EXPERT WITNESS REPORT

8 Example Street
Googong, NSW 2620

Client Name
JULY 19, 2024

DEVIATION FROM THE PLANS - GARAGE BOUNDARY WALL

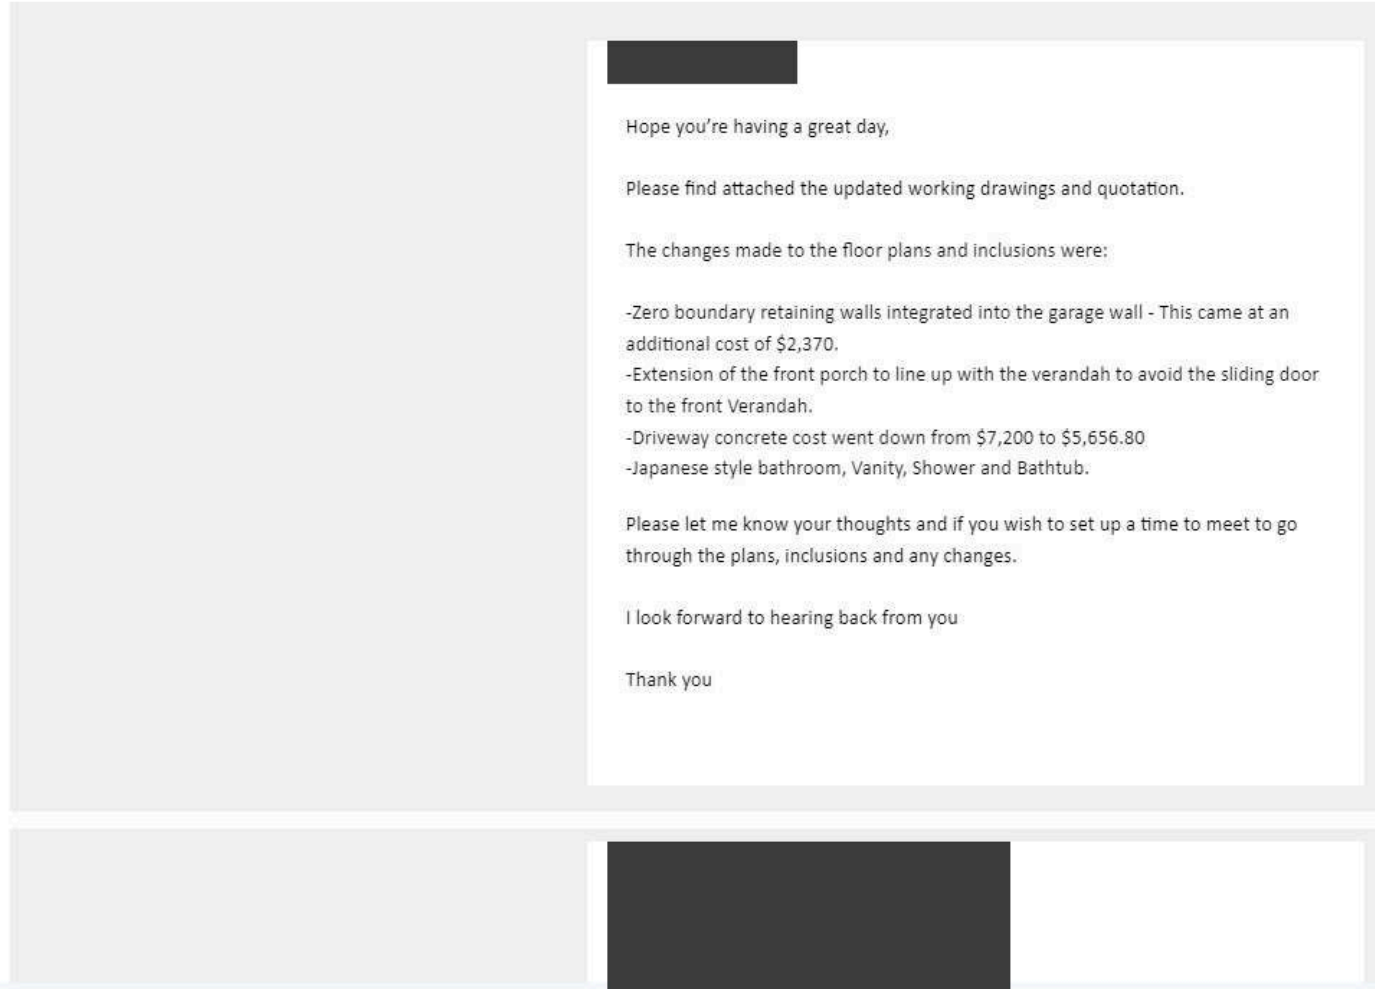
The approved plans show the garage's southern elevation gutter to be installed outside the wall, which positions the external garage wall 180mm from the boundary. However, the construction deviates from these plans as the gutter is installed on top of the garage wall, yet the wall has not been moved to align with the zero boundary. If the gutter had been installed outside the wall as per the plans, the wall could have been built on the boundary, potentially increasing the garage size by 0.18m x 5.5m (0.99m²). This discrepancy should be checked by the building surveyor.

DEVIATION FROM THE PLANS: RIGHT SIDE PILLAR MISALIGNMENT

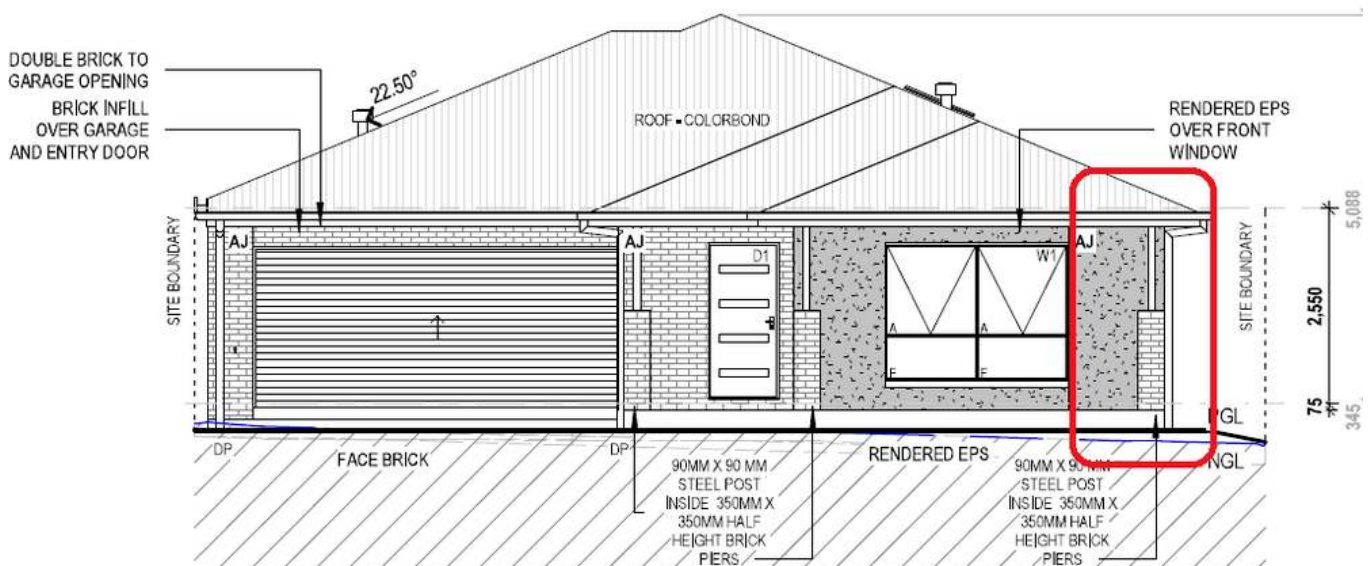
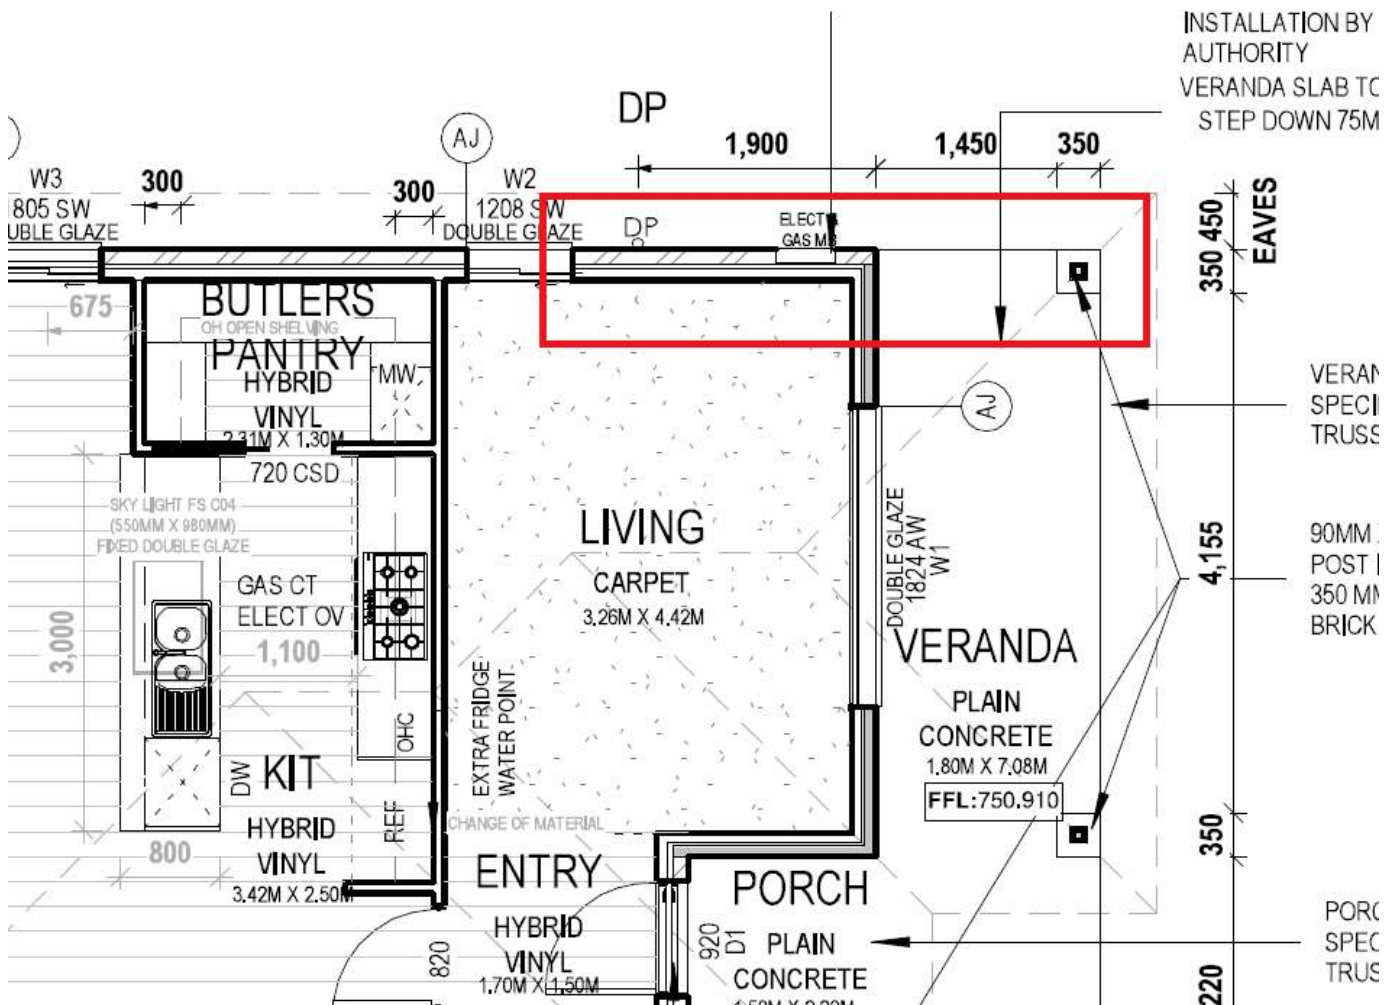
The right side pillar's external face is designed to align with the northern external wall as per the approved plans. However, the pillar has been constructed approximately 127mm inside the intended position. This deviation has led to inadequate support for a 127mm wide section of the concrete path, resulting in a 45-degree corner crack. The observed crack indicates tension at the edge of the pillar, suggesting structural stress that caused the initial crack and may lead to further deterioration. This issue requires immediate attention to prevent potential future structural damage.

DEVIATION FROM THE PLANS: MIDDLE PILLAR MISALIGNMENT

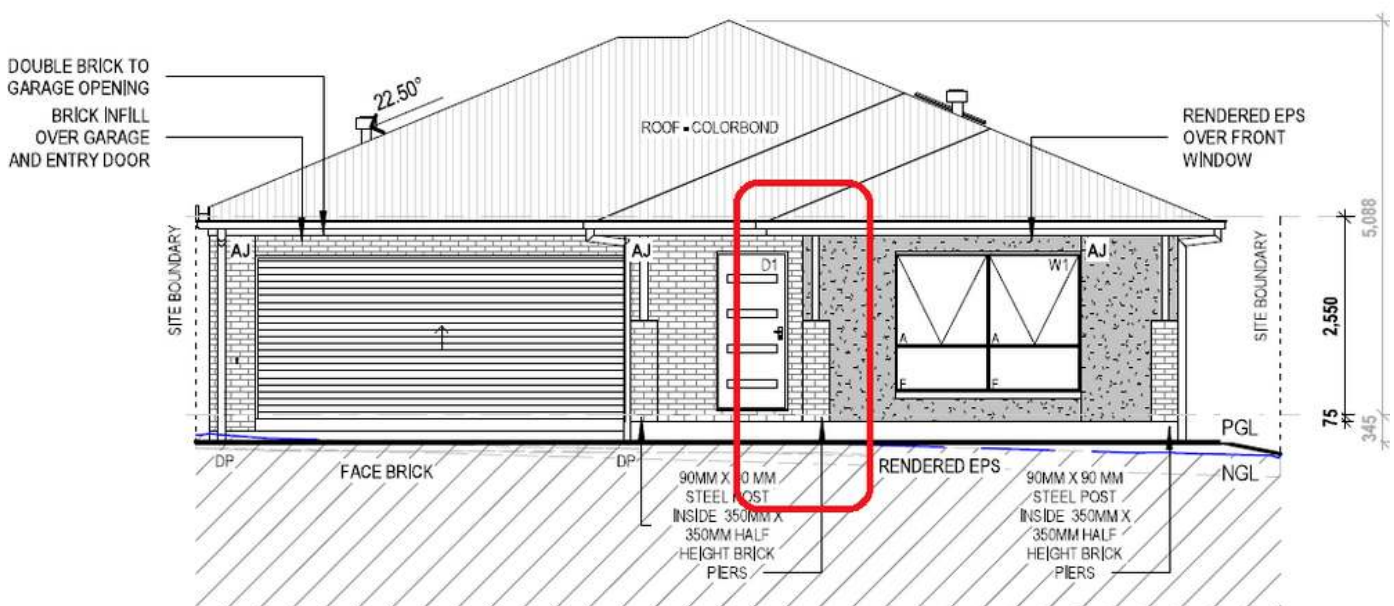
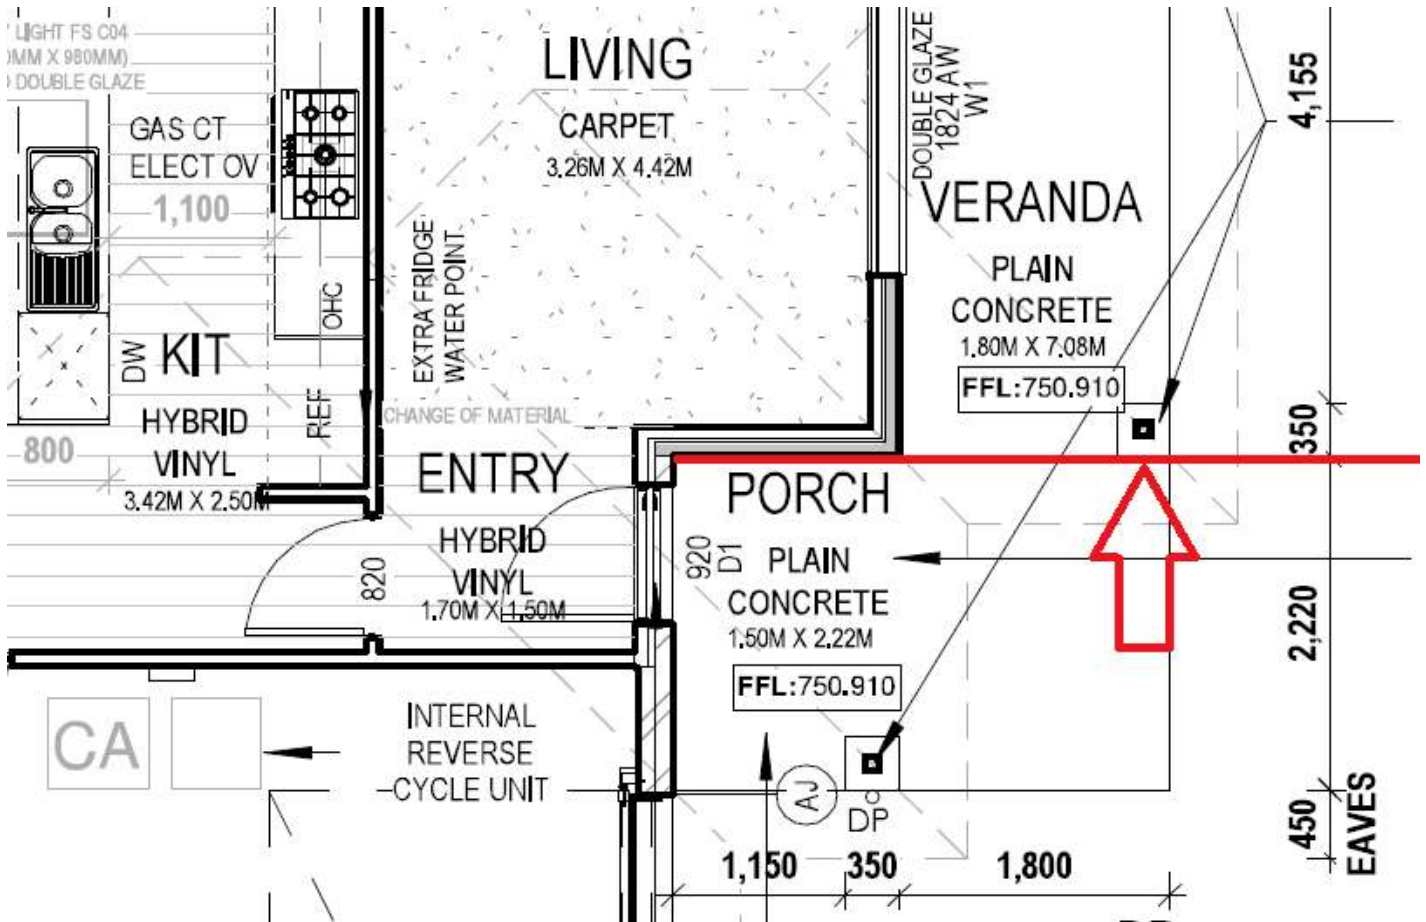
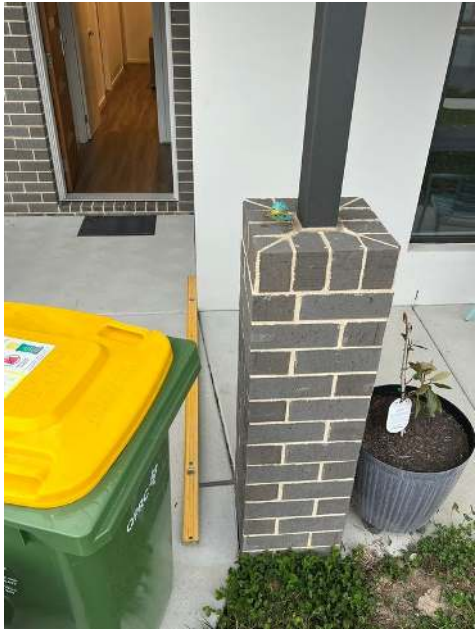
The working drawings specify that the middle pillar's southern face should be flush with the adjacent wall next to the entry door. However, the middle pillar has been constructed approximately 140mm north of the intended position.

DEVIATION FROM THE PLANS: LEFT PILLAR MISALIGNMENT

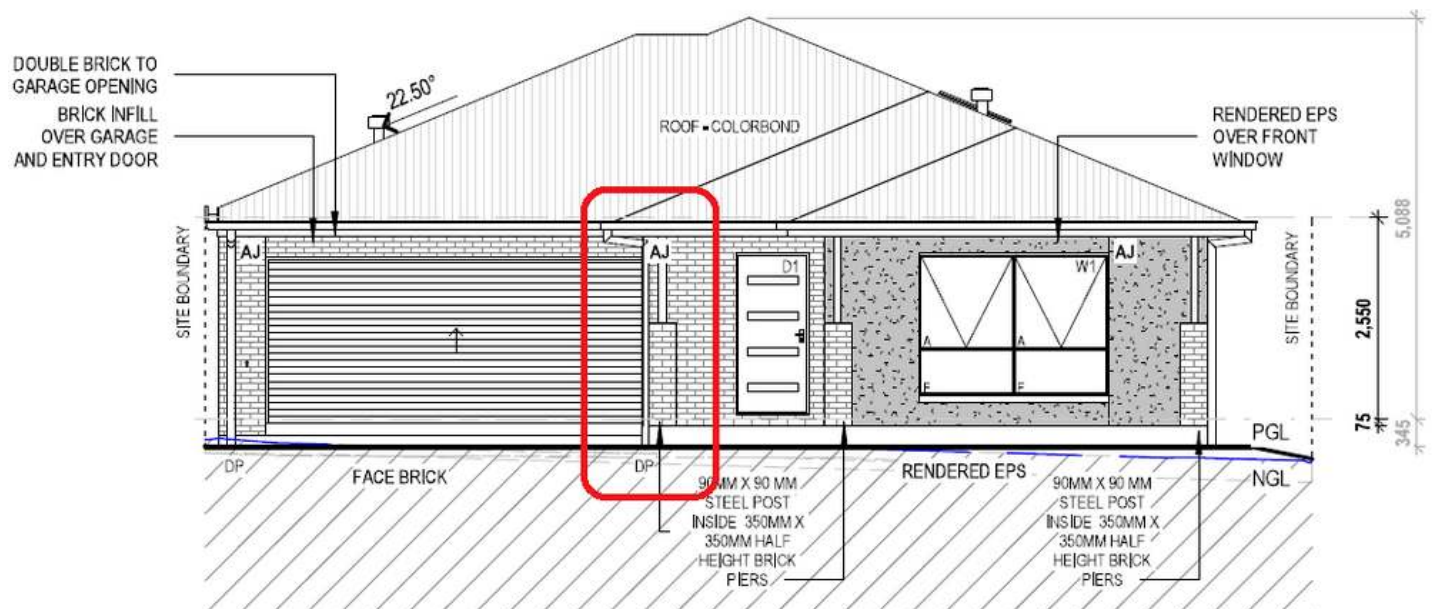
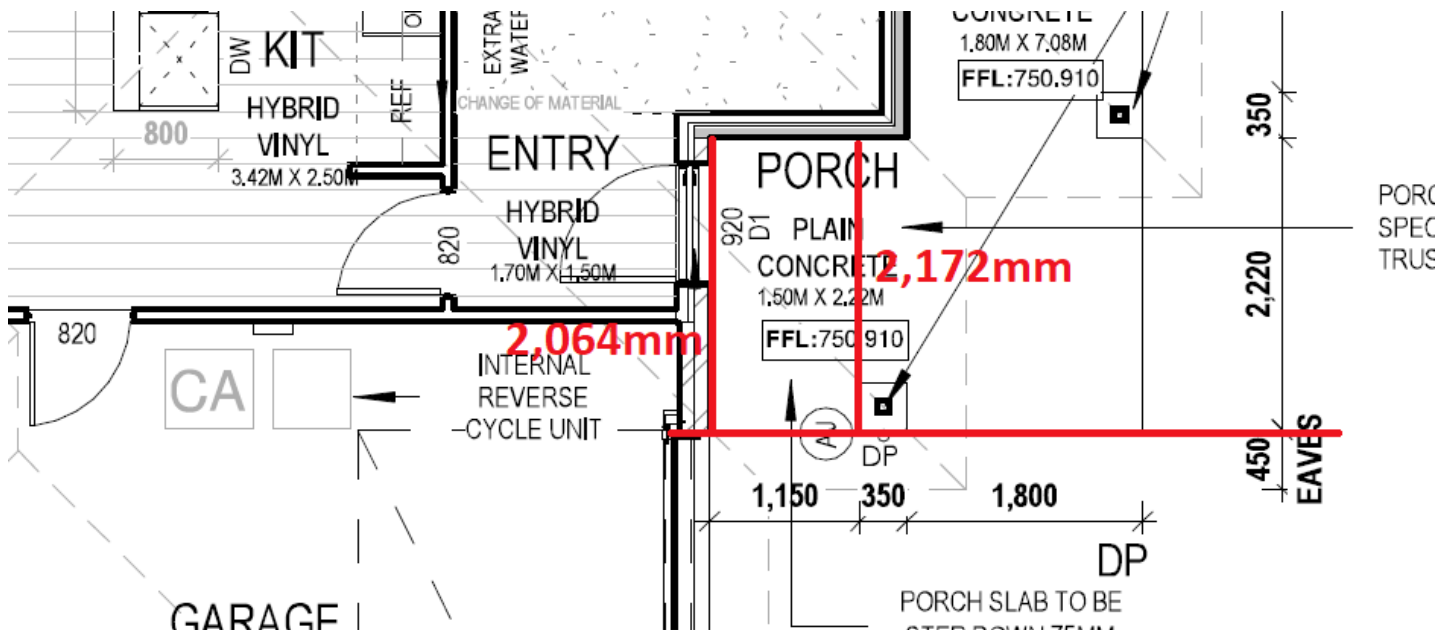
According to the working drawings, the left pillar should be in line with the internal face of the garage door wall. However, the pillar is constructed 108mm south of its intended position. The distance between the southern face of the pillar and the internal face of the garage door wall adjacent to the entry door should be equal. Currently, there is a 2064mm distance from the garage door internal wall and a 2172mm distance from the pillar, indicating a 108mm deviation from the plans. This discrepancy needs to be addressed to ensure alignment with the approved design specifications.

EXCESSIVE OVERHANG OF FRONT BRICK WALL

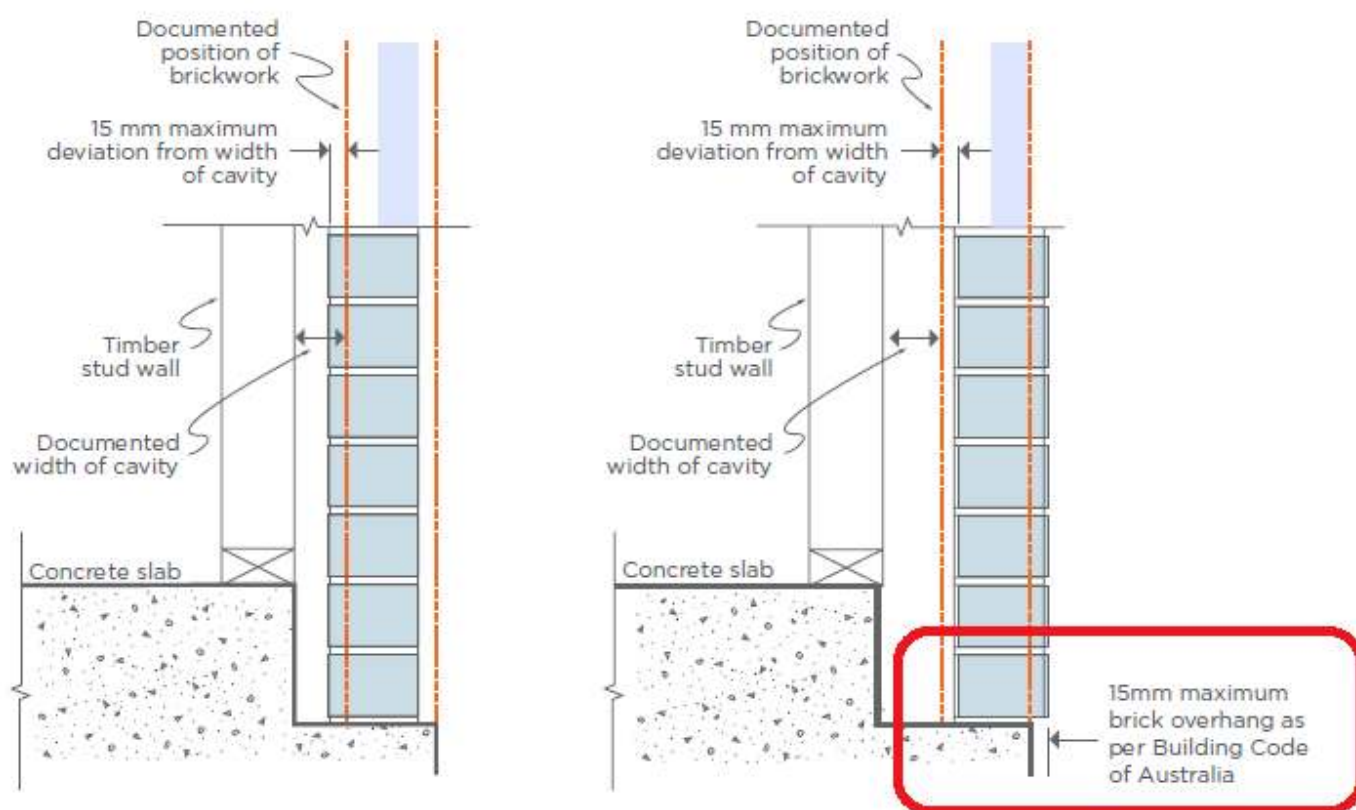
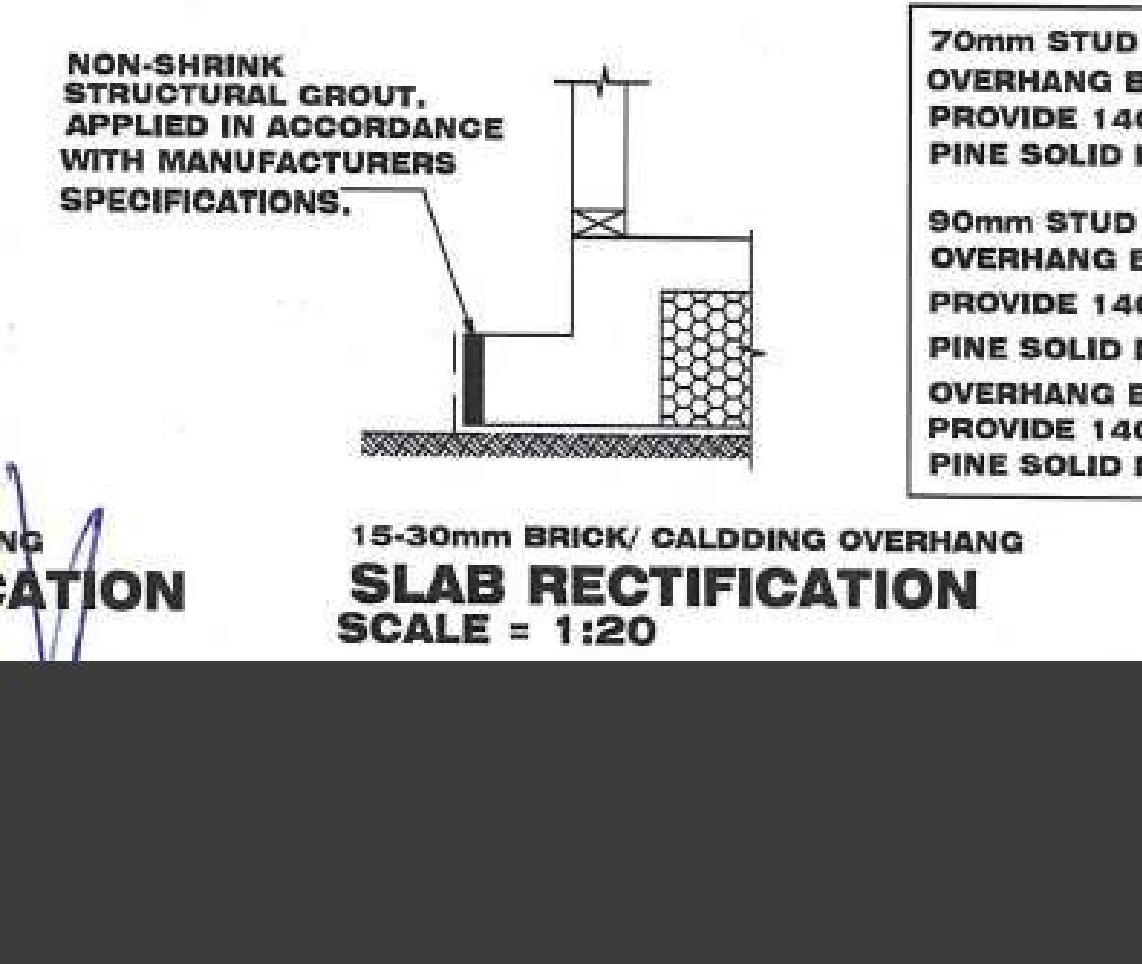
The designer engineer provided the rectification method for up to 30mm overhang. A specific design for 50mm overhang by the engineer is to be provided.

Note: The access to under the overhang brick is restricted by the Verandah Concrete. To rectify this issue, the verandah concrete to be removed and repoured after the rectification.

To rectify this defect, the slab must be extended or additional concrete added to support the brick wall above. This can be achieved by attaching a properly reinforced concrete extension to the existing slab, ensuring it is securely bonded and integrated. An engineer to design the rectification details to ensure compliance with NCC standards and restore the structural integrity of the wall.
